**Identification cards — Test methods —**

Part 6:  
**Proximity cards**

AMENDMENT 2: Test methods for  
electromagnetic disturbance

#### AMENDMENT 2: Test methods for electromagnetic disturbance

Figure Amd.2.1 — PCD immunity test (common for Type A and Type B)

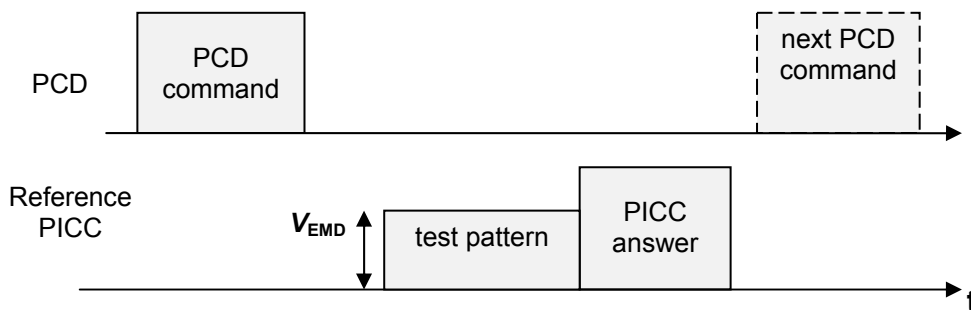
Insert the following new subclauses 7.1.6 and 7.1.7 before 7.2:

- d) Send the test pattern as shown in Figure Amd.2.1. The test pattern is a valid standard frame including one single byte (01011101)b. The initial load modulation amplitude  $V_{EMD}$  of the test pattern shall be sufficiently low so that the PCD detects the PICC answer sent in step e).

- f) Increase  $V_{EMD}$  by adjusting the voltage at CON1 until the PCD does no longer detect the answer correctly. This may be determined by monitoring the next PCD command following the PICC answer, see Figure Amd.2.1.

Figure Amd.2.2 — EMD recovery test sequence (common for Type A and Type B)

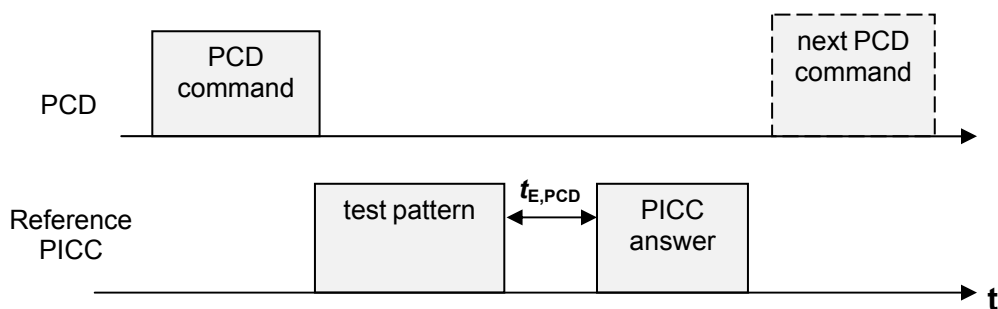
- e) Place the Reference PICC at a position within the operating volume of the PCD where 6 V (DC) is obtained at CON3.
- f) Send in sequence, as illustrated in Figure Amd.2.2 using the  $t_{E,PCD}$  associated with minimum FDT/TR0,

- a test pattern, which starts sending the two data bits  $b_1 = (0)b$  followed by  $b_2 = (1)b$  in a valid way to the PCD, but interrupts immediately after the second bit sent, as illustrated in Figure Amd.2.3 for Type A and Figure Amd.2.4 for Type B,

- a period with no load modulation for a duration of  $t_{E,PCD}$ ,
  - the appropriate answer to the PCD command.
- g) Check if the PCD behaves in the same way as if there was no test pattern. This may be determined by monitoring the next PCD command following the PICC answer, see Figure Amd.2.2.
  - h) Repeat steps f) and g) 10 times.
  - i) Repeat steps f) to h) replacing minimum FDT/TR0 with maximum FDT/TR0.
